ROAD SAFETY AUDIT RESPONSE REPORT

A27 / A29 FONTWELL AVENUE / ARUNDEL ROAD ROUNDABOUT IMPROVEMENT

STAGE 1

30 August 2017

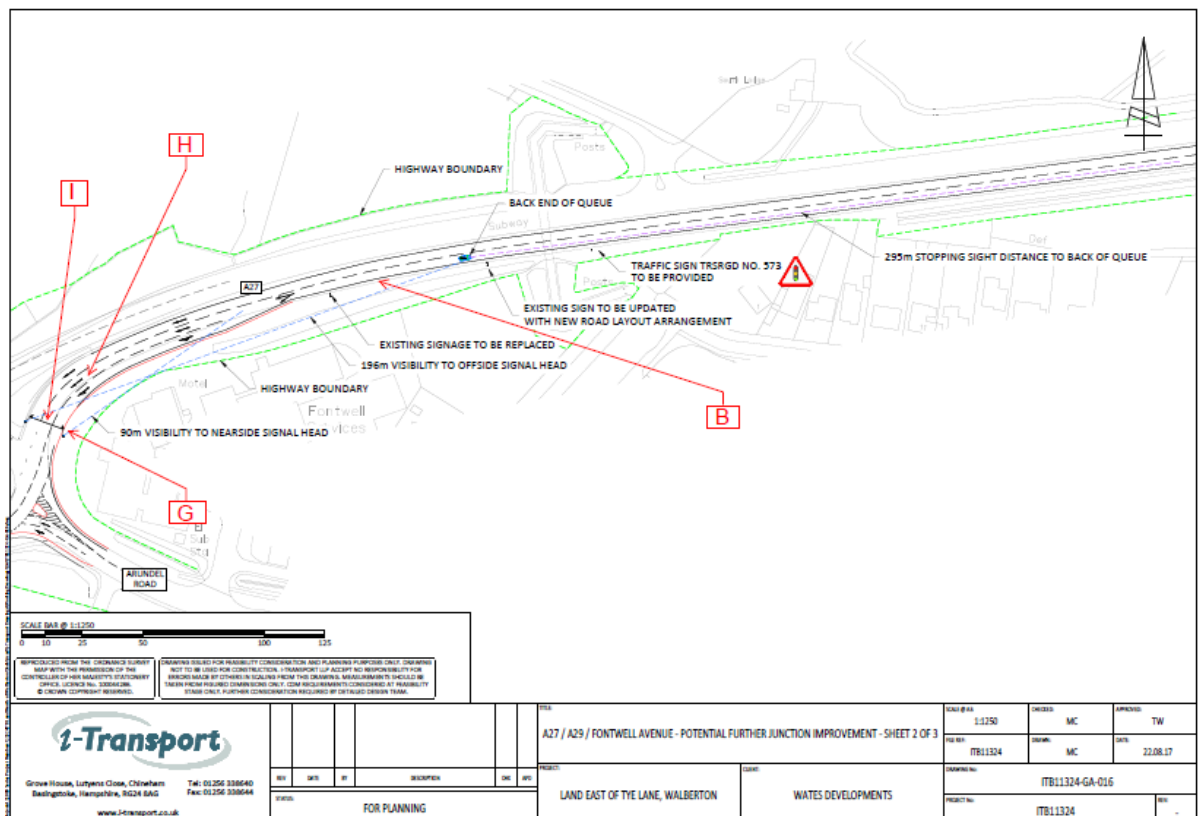
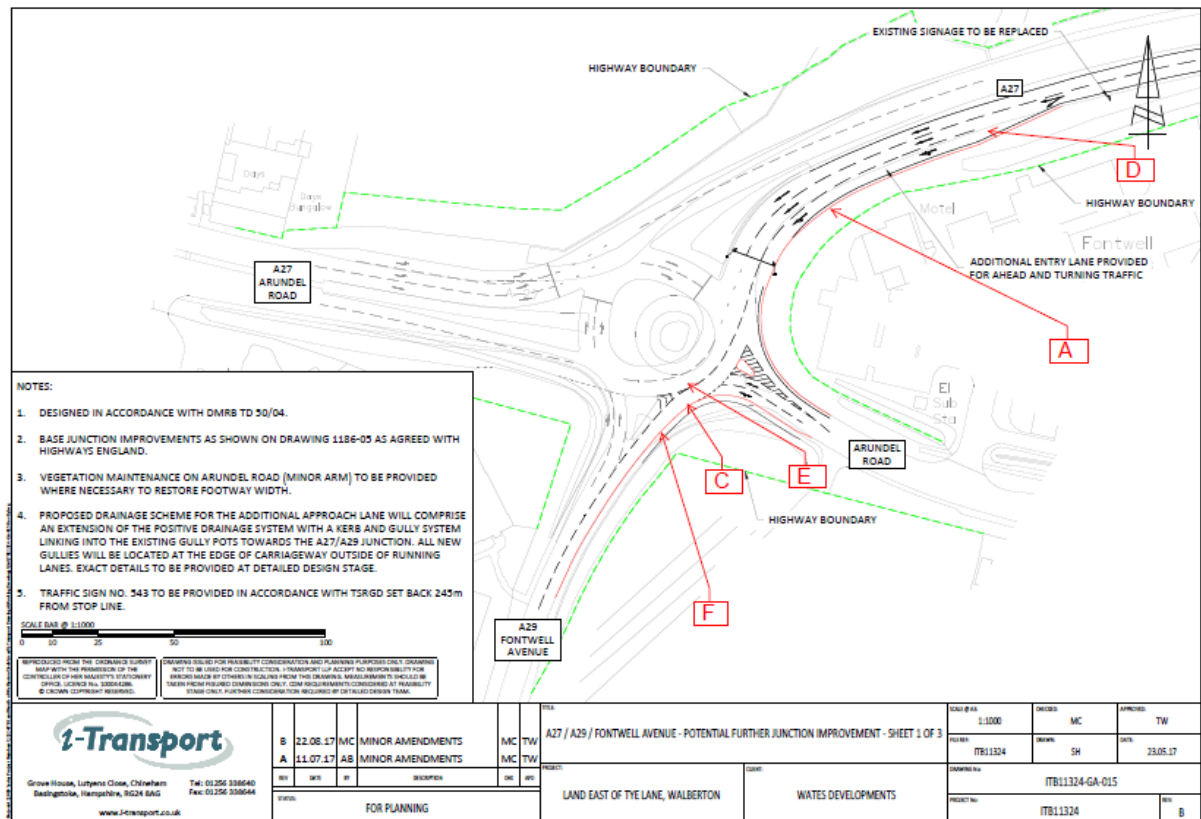
The signal heads are on an east west alignment, where sun dazzle could lead to red light running accidents, particularly if drivers cannot see the red / amber aspects.

Agreed – Traffic signal hoods to be fitted. A note is included on Drawing ITB11320-GA-015 Rev C to identify this.

SCALE @ A3: 1:1000	CHECKED: MC	APPROVED: TW
FILE REF: ITB11324	DRAWN: SH	DATE: 23.05.17
DRAWING No: ITB11324-GA-015		
PROJECT No: ITB11324		REV: C

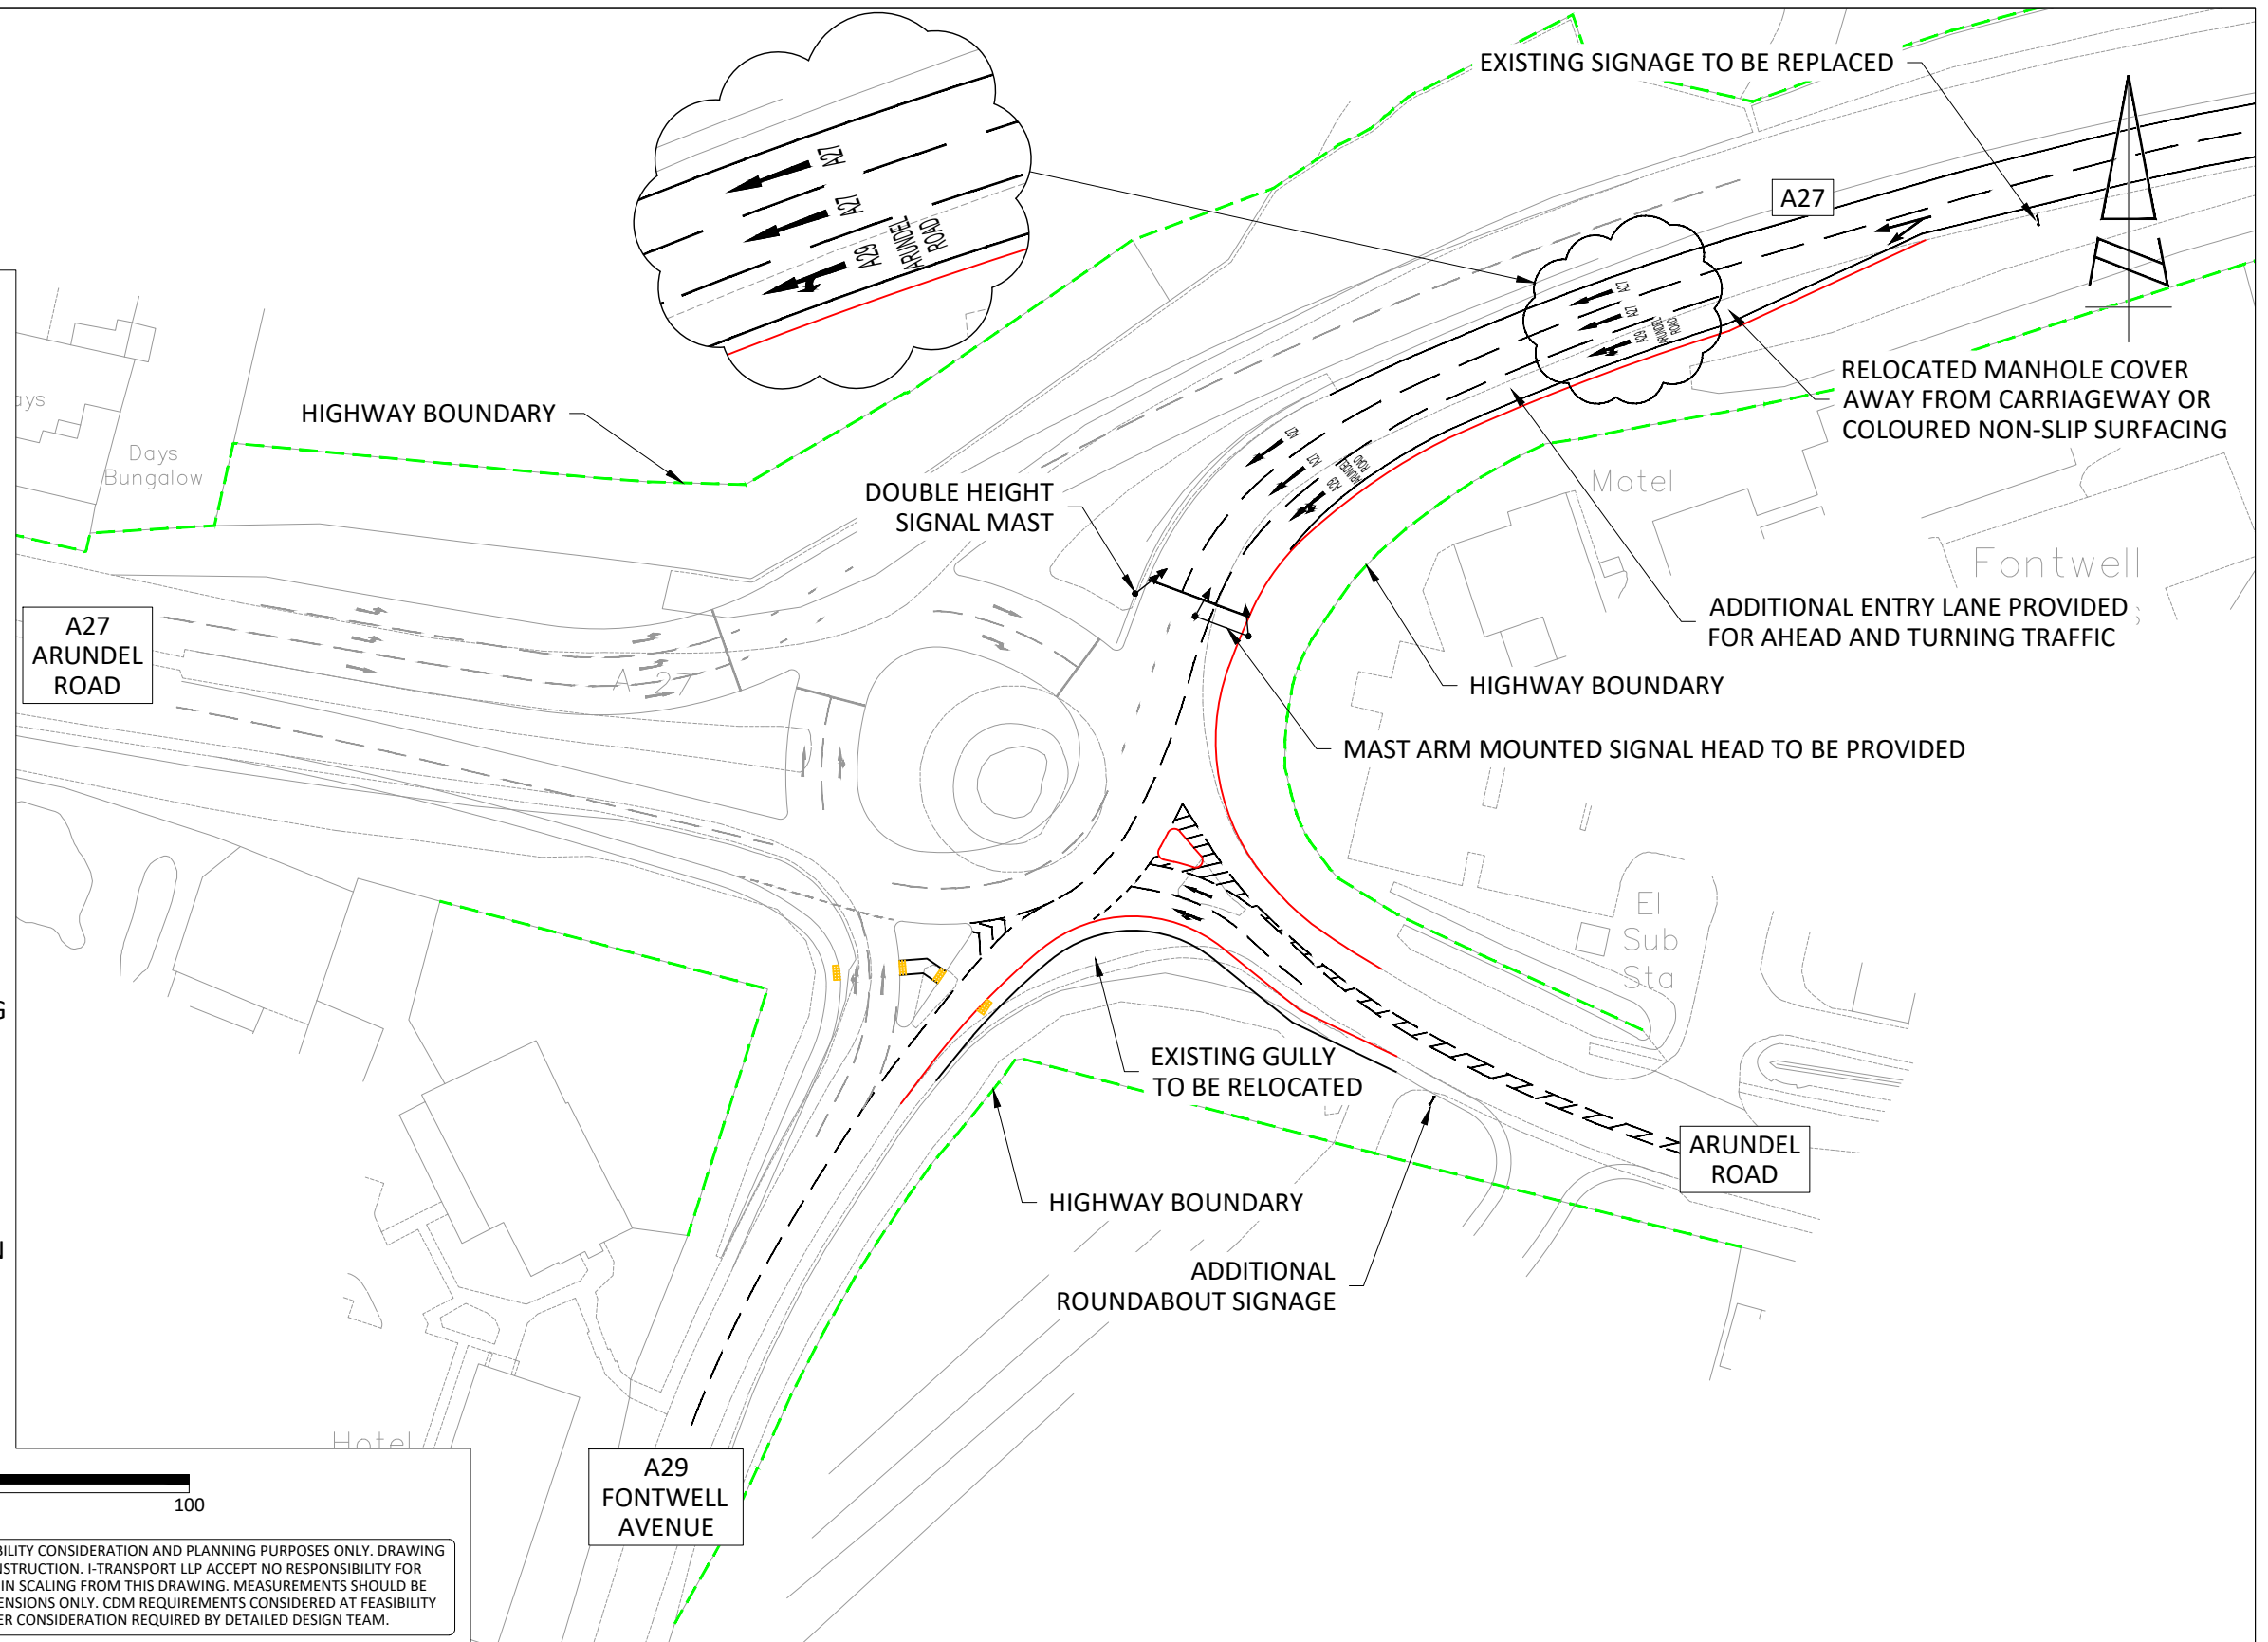
There is an existing ditch between the proposed additional entry lane and the restaurant / hotel complex, see figure 1 below, where no protection system is proposed. Vehicles that lose control and exit the carriageway may decelerate rapidly, where injuries may be severe in nature. In addition, in winter months the ditch could hold water, which could further impede the escape of vehicle occupants.

The carriageway alignment between Arundel Road and Fontwell Avenue is proposed to be changed with the kerblines being brought forward. However, there is a gully on the existing alignment, see figure 2 below, where no drainage provision is proposed. Surface water on the circulatory carriageway could lead to loss of control accidents, particularly under braking conditions.

On the A27 southwest bound approach to the roundabout, there is a manhole cover that is likely to be in the braking area on approach to the signal stop-line. This could lead to loss of control collisions under braking, particularly for two-wheeled vehicles

Entry path curvatures were provided for assessment, where the entry path from Arundel Road to the A27 for the east to west movement is greater than 100m, which is greater than the permitted maximum though it is recognised that the approved scheme also has an entry path curvature of 145m. An entry path radius exceeding 100m could lead to high entry speed and possible loss of control accidents, or conflict with circulating traffic and potential side swipe accidents.

The A29 Fontwell Avenue arm of the roundabout currently has uncontrolled pedestrian facilities, see figure 3 below. However, no dropped kerb provision is proposed, where pedestrians, particularly the mobility impaired may trip, which could lead to pedestrian accidents.

The Stopping Sight Distance (SSD) to the offside signal head is proposed at 196m, although this is below the required 295m, it is the same as with the approved scheme relating to Fontwell Meadows. Further, the SSD to the nearside signal head is proposed at 90m. In the event of the offside signal failure or queuing traffic obscuring the signal aspect, there is concern that approaching traffic will have insufficient time to react to a red aspect, which could lead to fail to stop accidents

Agreed – The recommendations of the Stage 1 Road Safety Audit Team, to undertake an RRRAP assessment to determine necessary protection from the ditch, will be carried out at the detailed design stage. This is noted on Drawing ITB11320-GA-015 Rev C.

Agreed – At the detailed design stage a full drainage design will be prepared and will identify any changes required to ensure the new carriageway areas are adequately drained, and that the risk of surface water ponding is reduced. This will require relocation of the gully on the existing circulatory carriageway to a position where it will accept surface water, and is noted on Drawing ITB11320-GA-015 Rev C.

- a) Coating the manhole with non-slip surfacing; or***
- b) Relocating the manhole outside of the proposed carriageway area.***

Agreed – The Arundel Road approach has been reconsidered with a view to improving deflection. Drawing ITB11320-GA-015 Rev C identifies a revised alignment which:

- ***Introduces a central hatched medium strip on Arundel Road;***
- ***Realigns the Arundel Road roundabout entry by around 1m to the north; and***
- ***Reconfigures the Arundel Road central traffic island and associated hatching.***

In addition, to aid conspicuity and reduce approach speeds, additional signage will be located on Arundel Road and is noted on Drawing ITB11320-GA-015 Rev C.

Agreed – Dropped kerbs and tactile pavements will be provided to improve crossing of A29 Fontwell Avenue, as shown on Drawing ITB11320-GA-015 Rev C.

Agreed – The visibility to the nearside primary signal head will be improved through provision of a mast arm mounted signal head, and the offside primary signal will be provided as a double height signal head to ensure it is visible above queued traffic, all as shown on Drawing ITB11320-GA-015 Rev C.
